To: Layla Rosales  
From: Hannah Hippely, Senior Planner  
Date: June 1, 2020  
Re: RZ-001111-2019 Erie Highlands Rezoning  
PUDA- 01151-2020 Erie Highlands PUD Amendment No. 3  
cc: Deborah Bachelder; Mike Weiher

# ERIE HIGHLANDS PUD ZONING MAP AMENDMENT NO. 3

**To:** Layla Rosales  
**From:** Shannon Moeller, Senior Planner  
**Date:** November 10, 2020  
**Re:** PUDA- 01151-2020 Erie Highlands PUD Amendment No. 3  
**cc:** Mike Weiher, Terracina Design; Fred Starr; Deborah Bachelder; David Pasic; Tyler Burhenn; Luke Bolinger; Patrick Hammer; Darren Champion

PUD PLAN

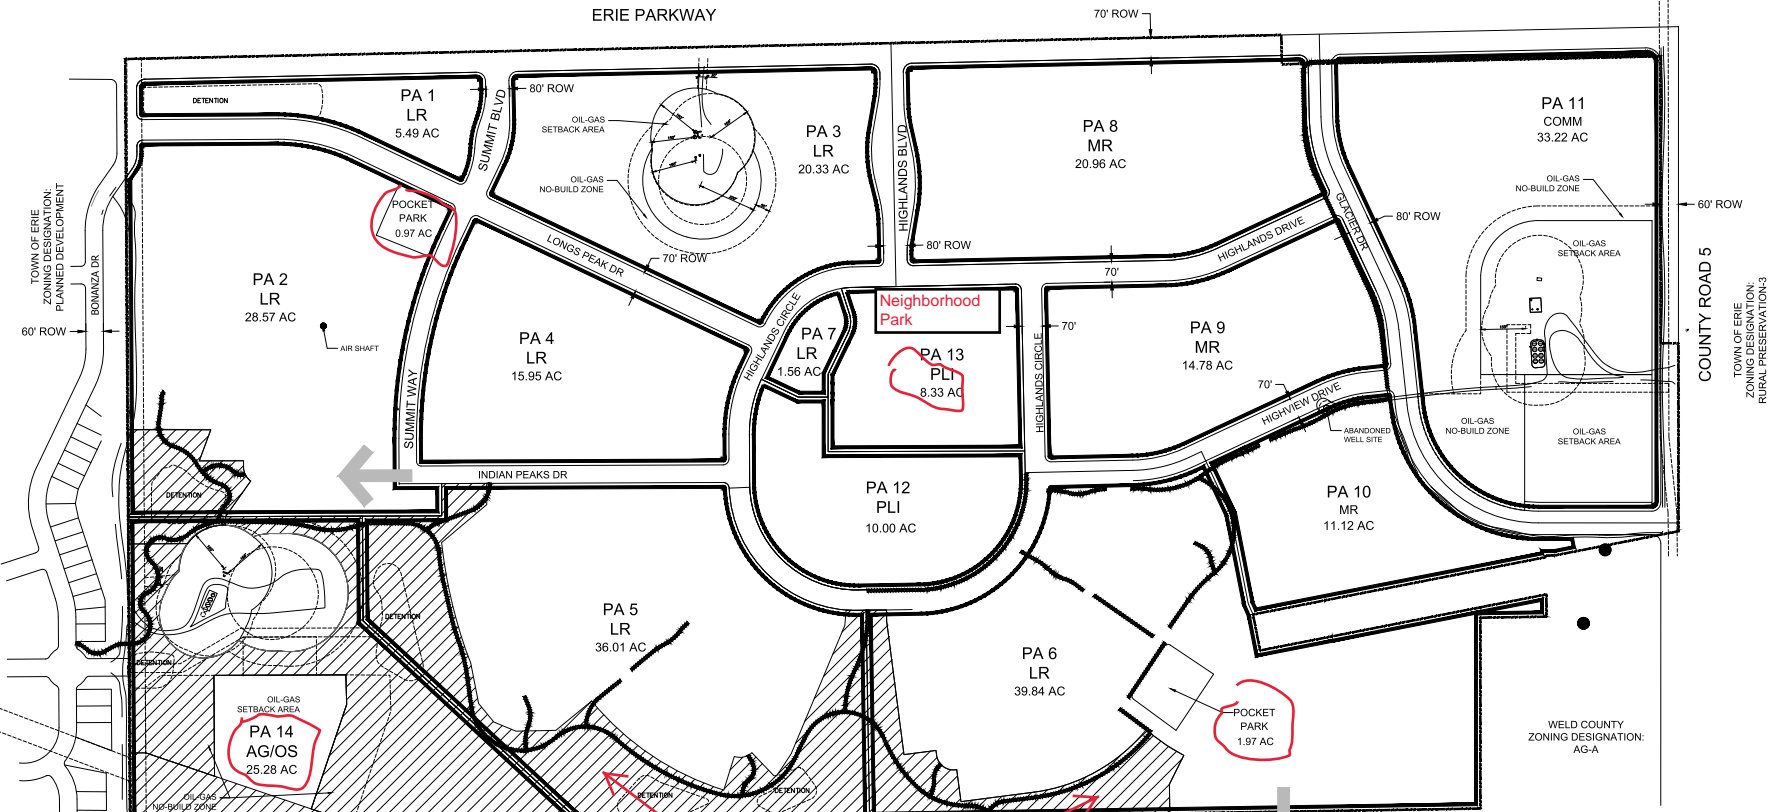
- The Table on the upper left calls out 1.97 acres of Pocket park. The plan shows two pocket parks (0.97 and 1.97) for a total of 2.84 acres of pocket parks.
- The Land Use Summary on Sheet 3 lists Public Open Space Provided. These areas are not labeled on the plan. The tabulation would be clearer if these open spaces were labeled on the plan. They appear to be sub areas in each Planning Area.
- The Development Summary on the upper right corner of Sheet 2 lists Parks and Open Space as 53.22 acres. We are having a hard time understanding what is included in this number.
- PA 14 is 8.41 as park land but not included in the open space column.
- PA 13 is listed as 8.33 on the plan and 8.41 in the Land Use Summary.
- We suggest the plan and all tabulations be coordinated for consistency and clarity.

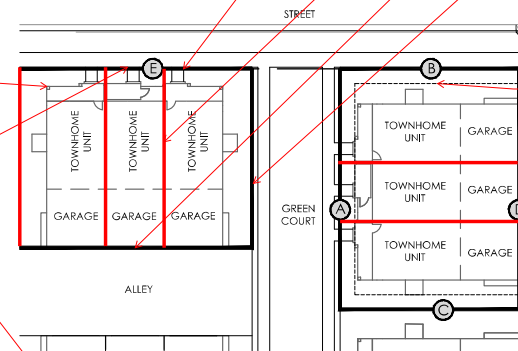
Add dashed lines delineating setbacks

Label - D?

Label - C?

Street Side Setback (B) is listed as 15' which doesn't appear consistent with what is shown for the dashed lines. Please clarify or revise dashed lines.

Are there encroachments, porches and/or window wells in setbacks? Please clarify standards around these items.

Please clarify how porches factor into the proposed front setbacks and right of way to structure requirements.

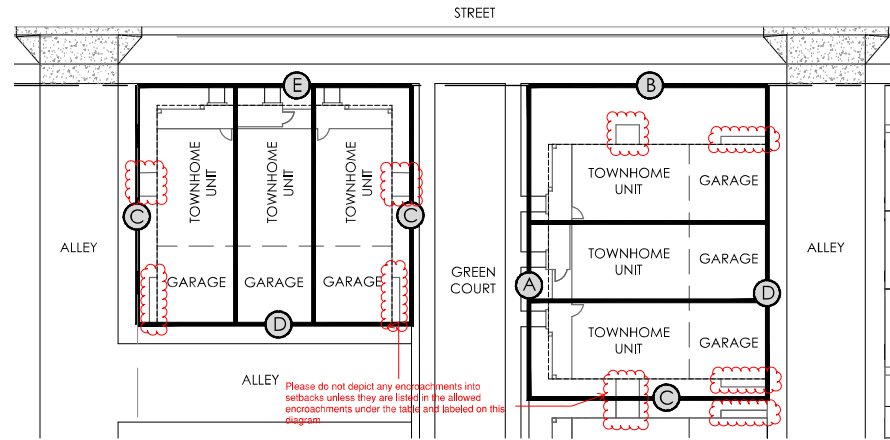
Please confirm 2' will be adequate for planned window wells

As the UDC architectural standards require a minimum 12" roof overhang, staff recommends including this encroachment language which also allows the encroachments to be closer than 5' to the property line which is the closest permitted by the UDC.

Please note that it is not permitted for rear garages at a 0' setback to have an eave overhang cross the property line into the alley. If garages are built at 0', no rear roof overhang would be permitted.
